**DEPARTMENT OF TRANSPORTATION
STATE OF GEORGIA**

FILE NH-IM-75-2(213) Henry County **OFFICE** Preconstruction
P. I. No. 312160
Jodeco Road over I-75 **DATE** November 30, 2004
FROM  Margaret B. Finkle, P.E., Assistant Director of Preconstruction
TO SEE DISTRIBUTION

Subject: Concept comments NH-IM-75-2(213)

PROJECT CONCEPT REPORT

JODECO ROAD BRIDGE OVER I-75

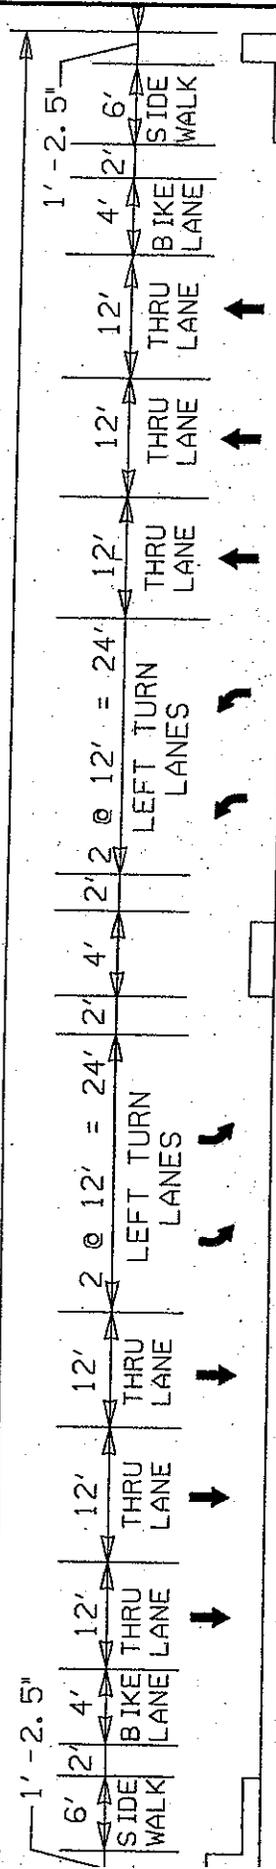
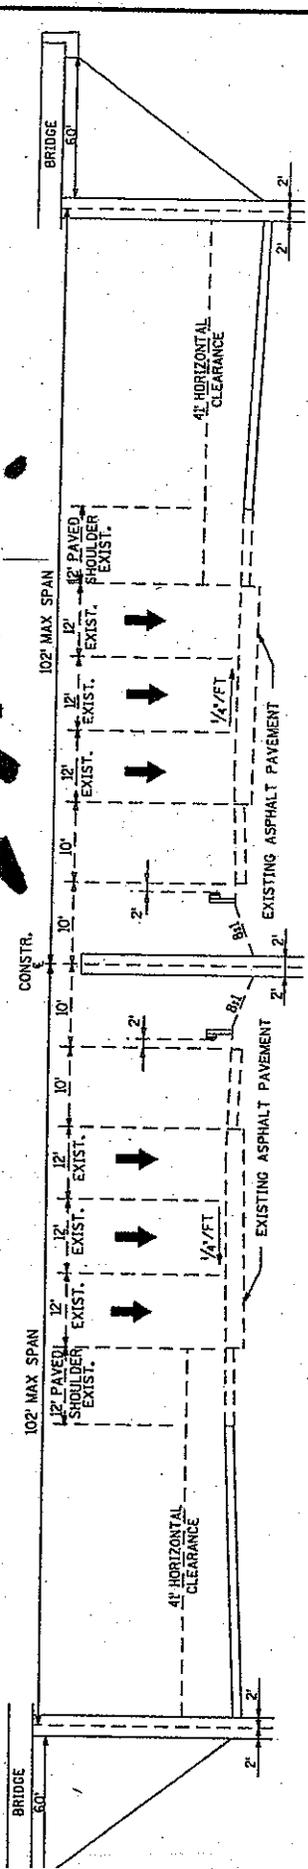
1. Adding up the lane widths under the bridge shows that the maximum span length is 121 feet rather than the 102 feet shown on the drawing.
2. We would prefer that GDOT use a full 10 foot shoulder rather than the 4 foot shoulder shown as the inside shoulder on the mainline.
3. We suggest installing a wall rather than slope paving at bents 1 and 5. This is in pursuit of the ultimate build out of this corridor which we have discussed and will continue to discuss with GDOT.

CONCEPT PLAN
I-75 @ JODECO ROAD/C.R. 824
INTERCHANGE IMPROVEMENT
 NOT TO SCALE
 MARCH 2003

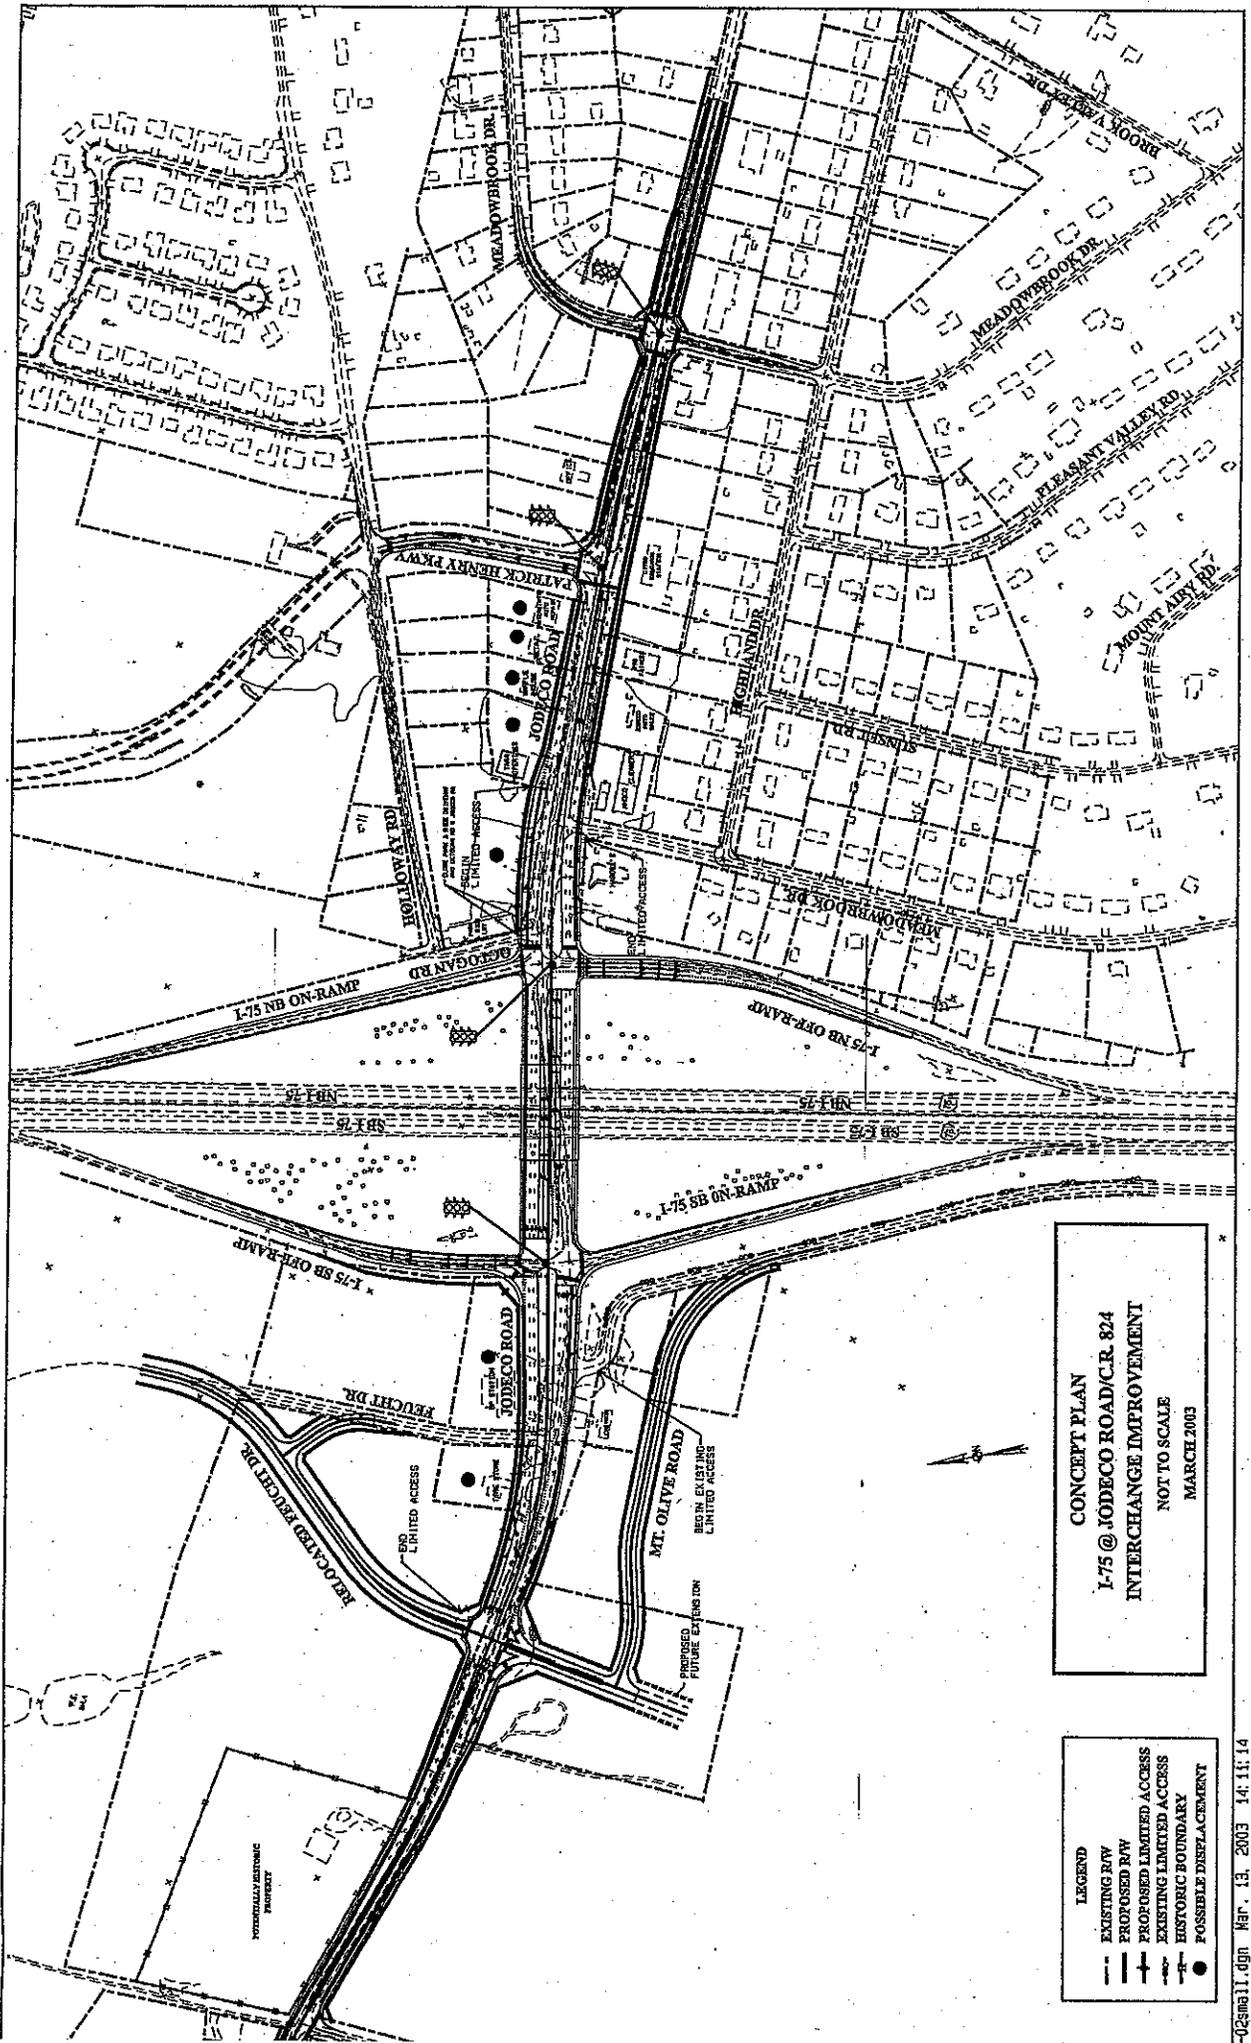
1. **Comment:** The right-of-way areas are unclear on the concept layout as to what parcels will and will not be affected.

2. **Comment:** A decision needs to be made as to whether a cul-de-sac or right turn bend needs to be shown at the intersection of Meadowbrook Drive. How will access be changed for properties around this intersection?

3. **Comment:** Change Feucht Drive. Where does Feucht Drive go?

3. **Comment:** Check the need for a traffic signal at Meadowbrook Drive. Build Meadowbrook intersection for a future signal.

4. **Comment:** A Park & Ride lot cannot be closed and must be cleared with Office of Environment and Location.

10. **Comment:** Show Frontage Road options on plans for Public Information Meeting.

11. **Comment:** Henry County agrees on closing Meadowbrook Drive from Highland Drive to Jodeco Road and leaving only a driveway for the Hardee's property.

Henry County commented that the road labeled Chambers Road is called McCullough Road and the road labeled McCullough Road is called Plantation Boulevard. Ms. Poshedly said the labeling on the concept layout would be corrected. *(Field investigation revealed that the street name signs indicate Chambers Road and Plantation Boulevard. The concept layout was relabeled accordingly)*

Response: MAAI will verify actual right-of-way on the freeway and discuss with the GDOT Right-of-Way office to get a more accurate account.

Response: After the property line information was placed on the concept layout plan, it was decided that a 25 mph bend with a cul-de-sac could be used at this location and that Meadowbrook Drive from Jodeco Road to Highland Drive could become a driveway to serve the Hardees' property. Access to the other properties at this intersection would not be affected by this modification.

Response: Feucht Drive presently serves a restaurant. The vacant land around Feucht Drive is the property of one major landowner. Consequently, it was decided to show a new access drive that would bend and "T" into Feucht Drive. It was also stated that MAAI should tighten the horizontal curve and tie the dirt road away from the intersection.

Response: Traffic has been checked and initially, it does not appear that a traffic signal will be warranted the opening year. However, all preliminary design work would be done in anticipation of a traffic signal installation.

Response: The concept layout was modified to have the driveway access to the Park & Ride lot moved from Jodeco Road to Holloway Road, so that the operation of the existing Park & Ride lot can be maintained.

Response: The proposed frontage road in the southwest quadrant of the intersection will be shown with a note indicating that there is a proposed future extension that would tie into Jonesboro Road. Also, shown is a Mt. Olive Road Connector from the Proposed Frontage Road to the existing Mt. Olive Road that parallels I-75.

Response: The concept layout was modified accordingly with a 25 mph bend at the intersection of Meadowbrook Drive at Highland Drive.
